Report of the Committee on**National Electrical Code®****James W. Carpenter**, *Chair*International Association of Electrical Inspectors, TX [E]
Rep. International Association of Electrical Inspectors**Mark W. Earley**, *Secretary (Staff-NV)*
National Fire Protection Association, MA**Jan A. O'Connor**, *Recording Secretary*
National Fire Protection Association, MA**James E. Brunssen**, Telcordia, NJ [UT]Rep. Alliance for Telecommunications Industry Solutions
Michael I. Callanan, National Joint Apprentice & Training Committee,
MD [L]

Staff Liaison: **Mark W. Earley****Committee Scope:** This Committee shall have primary responsibility for documents on minimizing the risk of electricity as a source of electric shock and as a potential ignition source of fires and explosions. It shall also be responsible for text to minimize the propagation of fire and explosions due to electrical installations.**Report of the Committee on****Electrical Equipment of****Industrial Machinery****Michael I. Callanan**, *Chair*

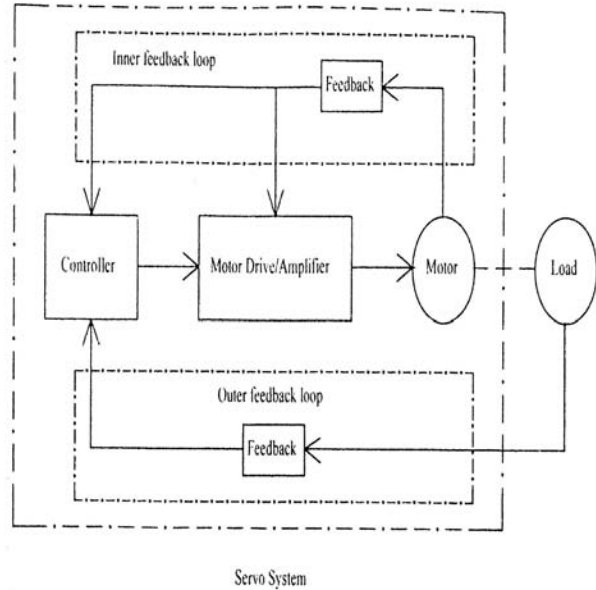
Submitter: George Schreck, Komatsu America Industries LLC
Recommendation: New definition to read as follows:
 Servo System: An Adjustable Speed Drive that has motion control by intentional command and is monitored by a feedback loop system.
Substantiation: To provide a common definition of term.
 This proposal was developed by Task Group 9, Servo Drives/Motors.
Committee Meeting Action: Accept in Principle
 Revise the recommendation to read as follows:
 New definition to read as follows:
 3.X. Servo Drive System*. A system consisting of a controller, servo amplifier, motor, and feedback device(s) providing for the positioning control of a motion axis through the use of velocity, acceleration, and deceleration.
 Add an annex A3.x.

Committee Statement: The committee made editorial corrections to more clearly convey the application of the definition. An annex item was added also.
Number Eligible to Vote: 20
Ballot Results: Affirmative: 20
Comment on Affirmative
 BLOODGOOD: A.3.X Add a dashed line between the motor and the positioned load to show the mechanical link.
 MONTEITH: Change the committee action accepted wording to read as follows with revised artwork and new definition of servo system:
 3.X Electrical Servo Drive System. A system consisting of a controller, servo amplifier, motor, and feedback device(s) providing for the positioning control of a motion axis through the use of velocity, acceleration, and deceleration.
 Add an annex A3, (revised artwork)

Recommendation: Revise Figure 6.2.2.1 as follows:

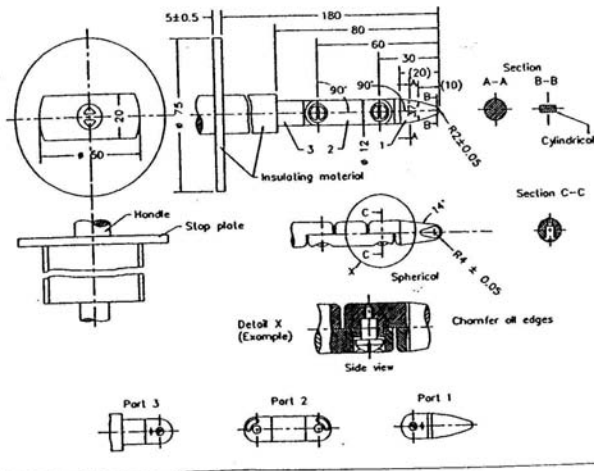
Add missing dimension for finger diameter of 12.5, dimension arrows already present

Substantiation: Missing dimension value 12.5 mm (0.5 inches) is typical dimension for standard test finger diameter for IP2 or other “finger safe” requirements. Also typical for dimension already used in existing text, NFPA 79:2002, 12.5.1.1 Exception No. 4, Table F.5.2 Degrees of Protection Against Access to Hazardous Parts Indicated by the First Characteristic Numeral, Table F.5.3 IP Code Elements and Their Meaning.

79-159 Log #31 **Final Action: Reject**
(Annex C, C.2, C.5, C.7)

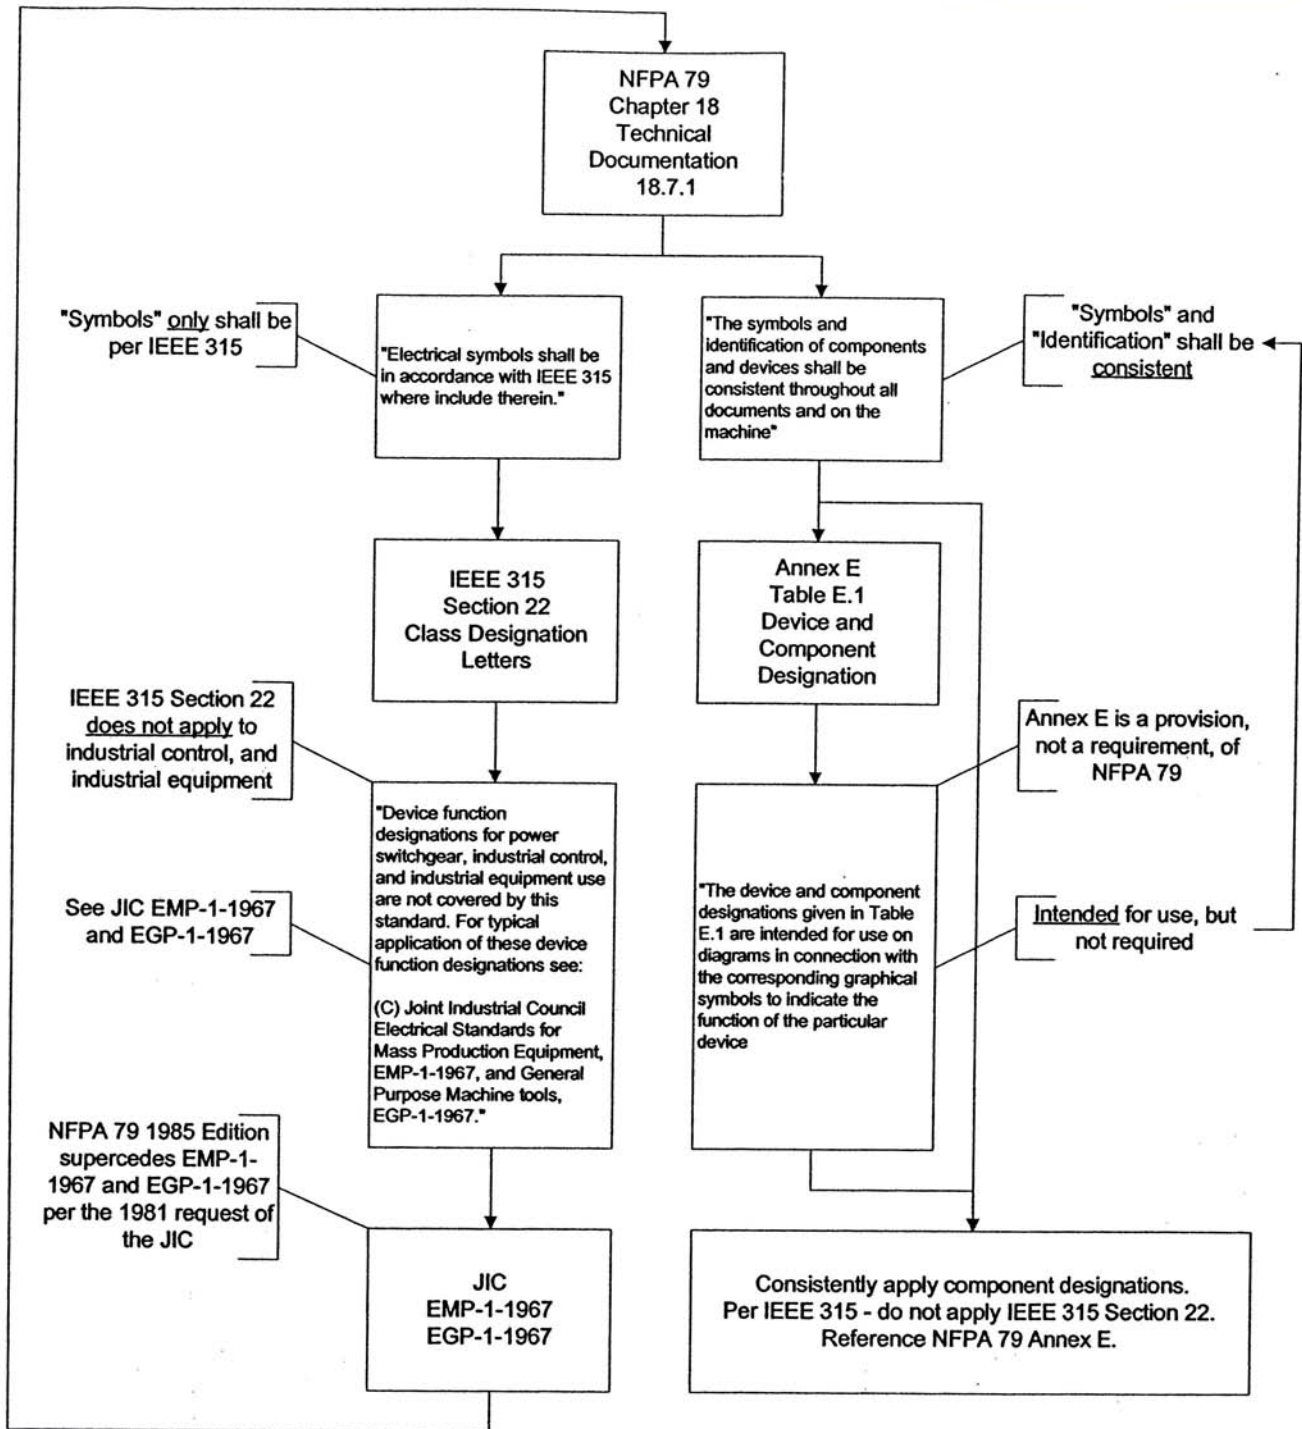
Recommendation: Revise Annex C as follows:
